RESOLUTION SETTING HEARING ON REQUEST FROM HUBBELL REALTY COMPANY (OWNER), REPRESENTED BY CALEB SMITH (OFFICER), FOR REVIEW AND APPROVAL OF PUD FINAL DEVELOPMENT PLAN FOR “GRAY’S STATION TELUS CONDOS,” FOR PROPERTY LOCATED IN THE VICINITY OF 1300 TUTTLE STREET TO ALLOW DEVELOPMENT OF THE PROPERTY WITH THE CONSTRUCTION OF TWO CONDO BUILDINGS CONTAINING 84 RESIDENTIAL UNITS

Communication from the City Plan and Zoning Commission advising that at their February 2, 2023 meeting, the following action was taken regarding a request from Hubbell Realty Company (owner), represented by Caleb Smith (officer), for the following regarding property located in the vicinity of 1300 Tuttle Street:

CONCEPTUAL PLAN, FIRST AMENDMENT GRAY'S STATION

6 GARAGE SIDE 2 (10 STALL) ELEVATION
SCALE: 1/8" = 1'-0"

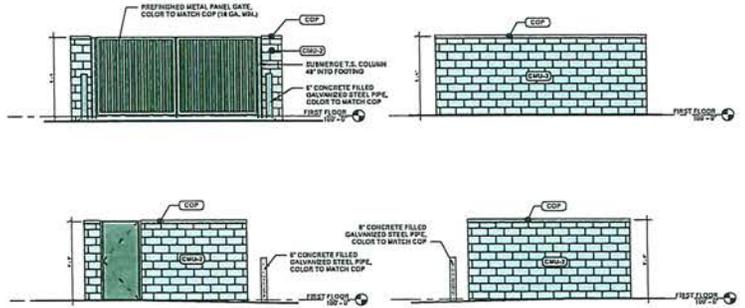
1. Provision of a "band" of architectural concrete masonry unit materials from grade up to 2' for the standalone garages that matches the concrete masonry units proposed for the condo buildings.
2. Provision of a sidewalk connection from the southeastern corner of "Building 2" that crosses the internal vehicular drive to link up with the north-south pedestrian pathway that bisects this development area.
3. Provision of more-detailed exterior façade materiality information that matches the standards outlined within the PUD Conceptual Plan.
4. Verification that all exterior façade glazing contains a minimum 50% transmittance factor and a reflectance factor of no more than .25.

NEW FRONT ELEVATION

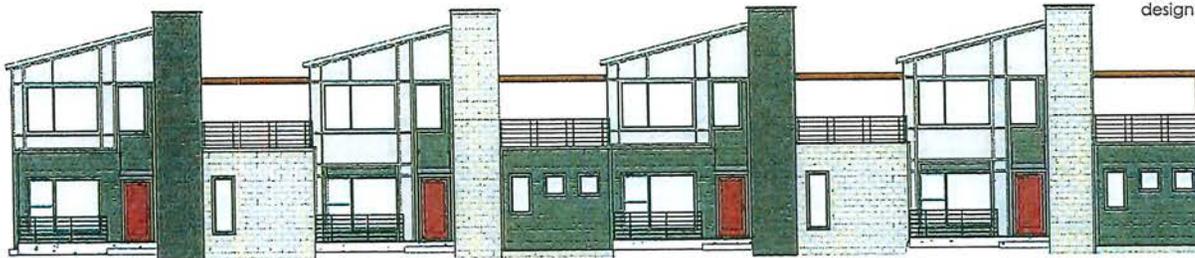
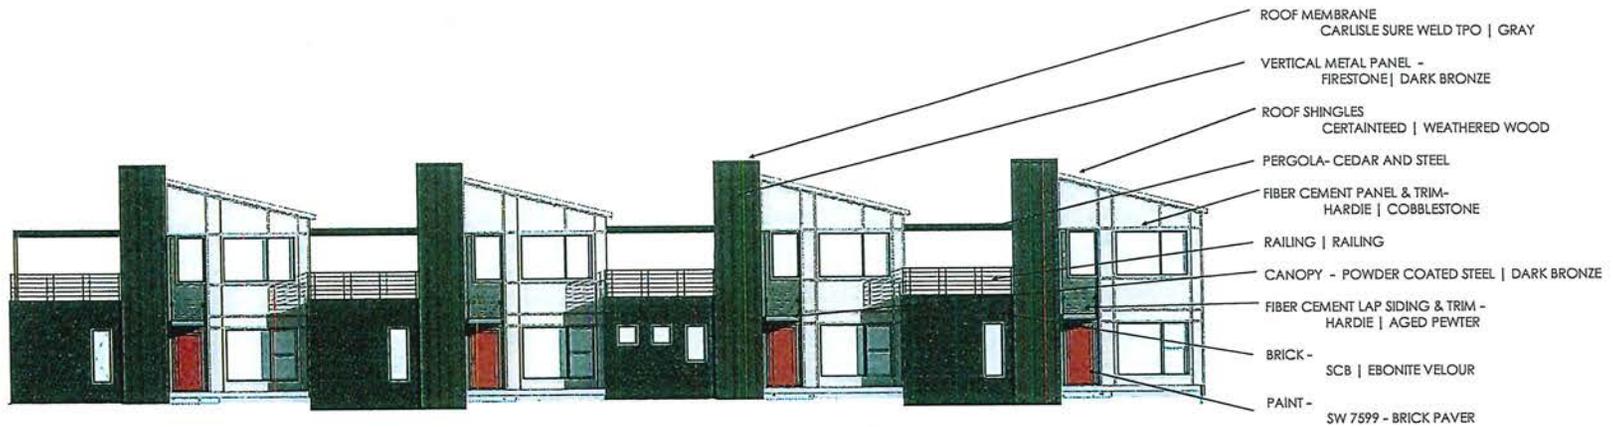
This elevation looked too busy and had too many design themes and variations.

- Revised vertical elements to all be the same color and revised material to dark metal panels with a vertical pattern.
- The cube-shaped building elements were revised from Hardie lap siding/stone to all stone, to unify the overall building design.

NEW FRONT ELEVATION

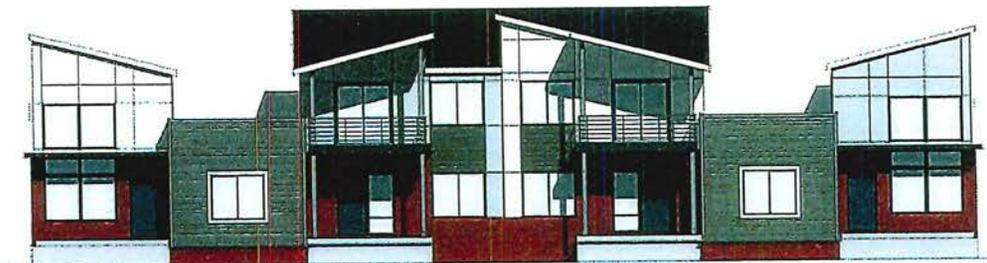
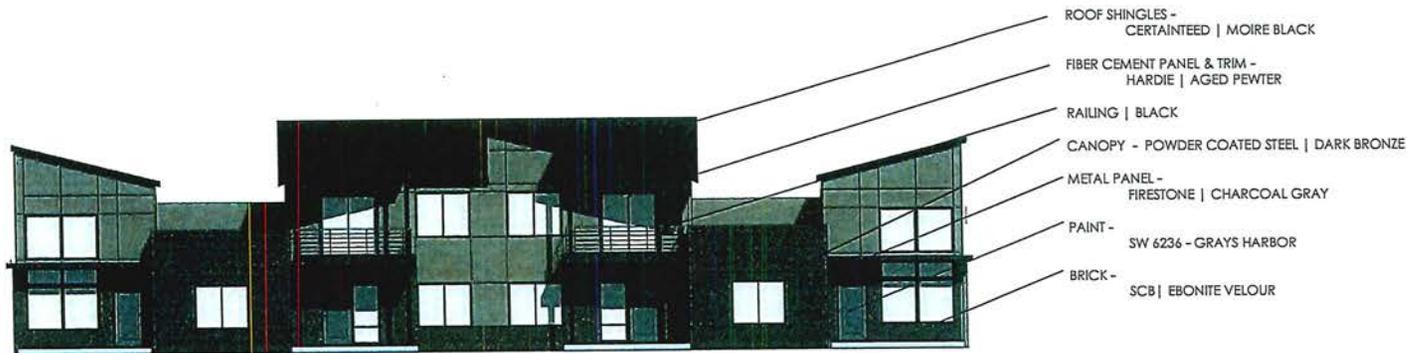
This elevation was too busy and the color scheme too light for this urban environment.

- Changed to a darker color scheme to achieve a more urban look.
- Changed Hardie lap siding on front to metal panels.
- Eliminated the white-colored Hardie panels and matched the panel color on both sides to achieve a unified appearance.
- Steel metal posts will be painted dark gray.
